Limited Site Plan Amendment, 82000018D, DANAC Stiles Property, Lot 6 of Block D

Date of Staff Report: 11/21/12

Description

Landscape Plan

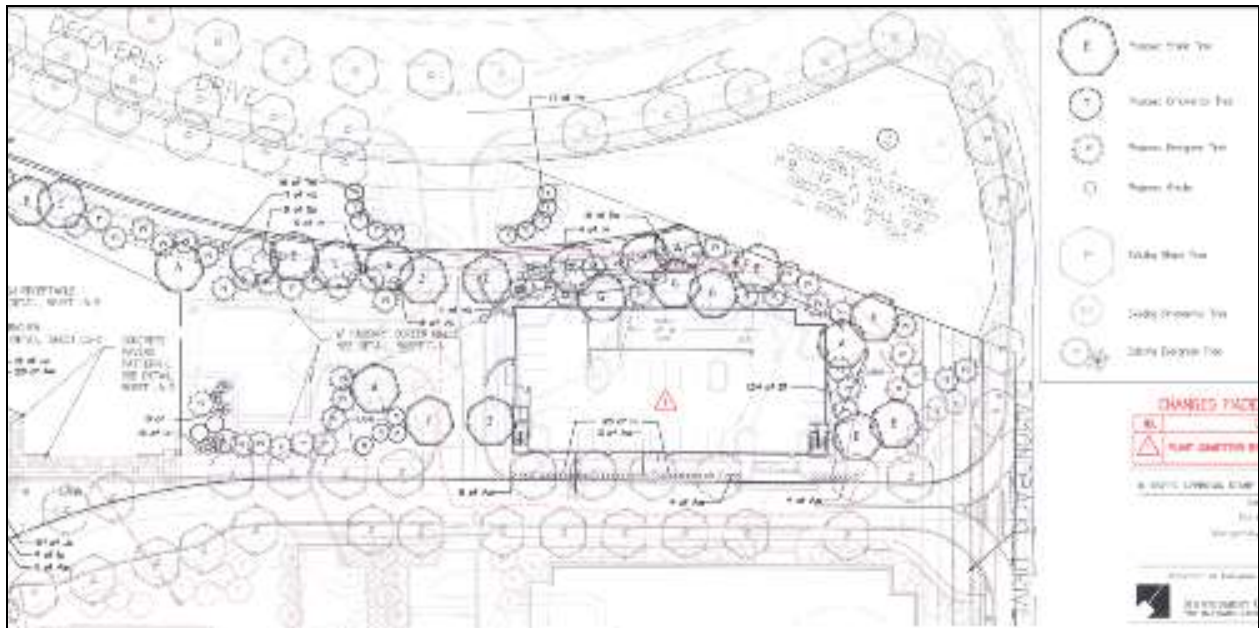
7. The Applicant must provide 8 bicycle parking spaces near the elevator in a well-lit area.
 8. The Applicant must revise the landscape plan to increase the height of the proposed green wall on the parking garage's south facade to extend to the top of the fourth parking level for at least ½ of the facade area.

Proposed landscaping is proposed around the parking garage's northern and eastern facades, serving to soften the four-story structure. The plant mixture will include shade, evergreen, and ornamental trees with shrubs and ground cover. A green wall is proposed along the parking garage's south facade. The height of the green wall is approximately 10 feet to the top of the first parking level. As conditioned, this wall will be extended to the fourth parking level over at least ½ of the facade to further soften the structure and enhance compatibility in relation to the proposed mixed use building on Lot 7. The lighting plan meets the requirements of the Zoning Ordinance to ensure pedestrian safety and efficiency. Staff finds that locations of buildings and structures, open spaces, and landscaping remain adequate, safe and efficient.

FC-1

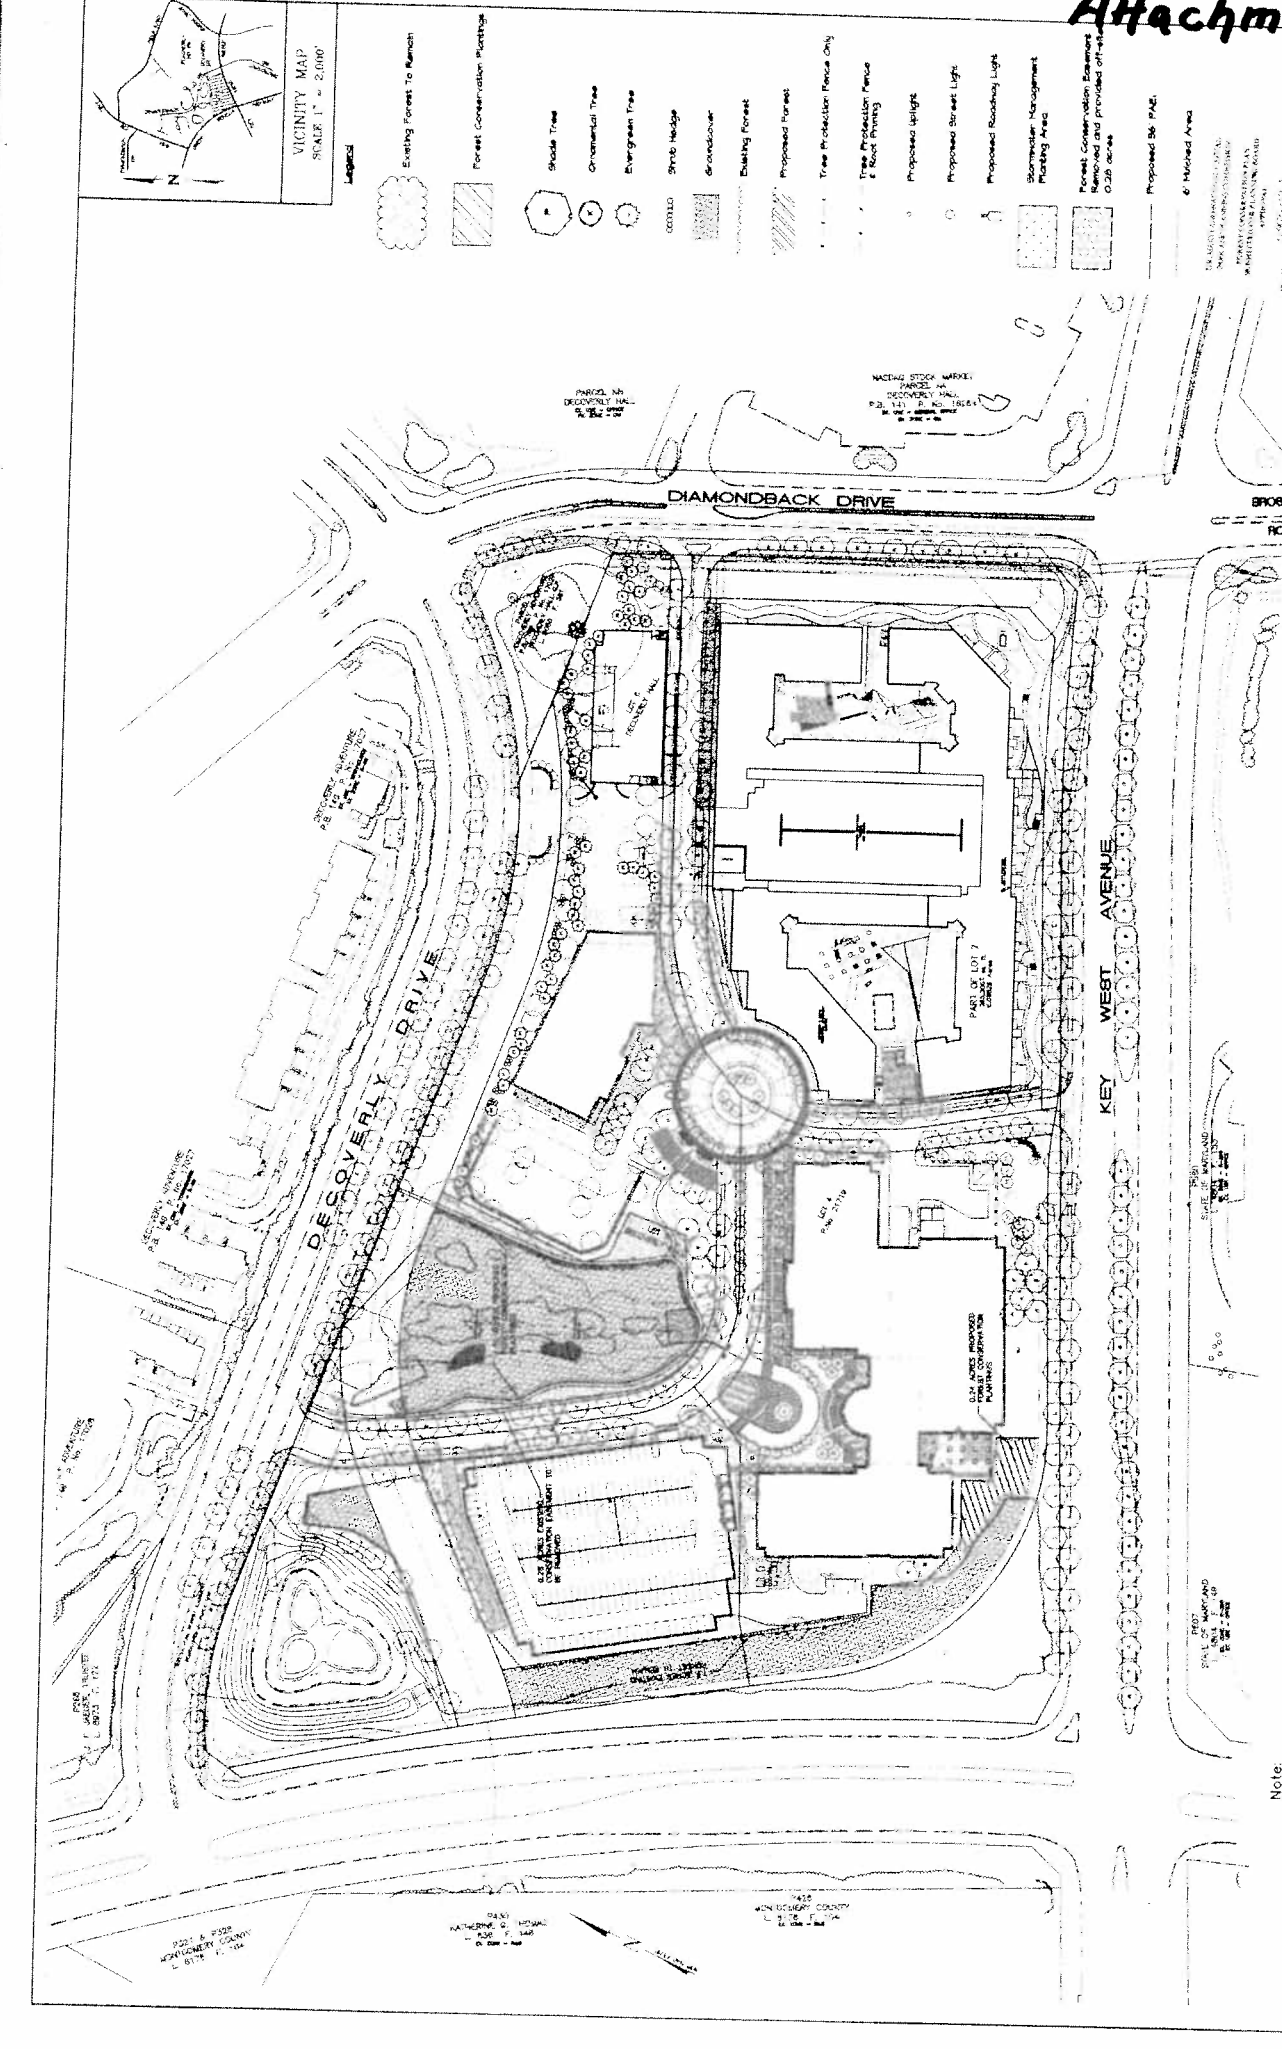
2. The Applicant must submit a Certificate of Compliance Agreement for reforestation/afforestation to be approved by M-NCPPC General Counsel; forest bank credits must be purchased prior to issuance of sediment and erosion control permits.

3. The final Sediment Control Plan must be consistent with the limit of disturbance shown on the Amended Final Forest Conservation Plan (FFCP).
 4. The Applicant must comply with all tree protection and tree save measures shown on the approved Amended FFCP, including recommendations specified in the arborist's letter dated May 24, 2012 and included on Sheet FC-4 of the Amended FFCP.
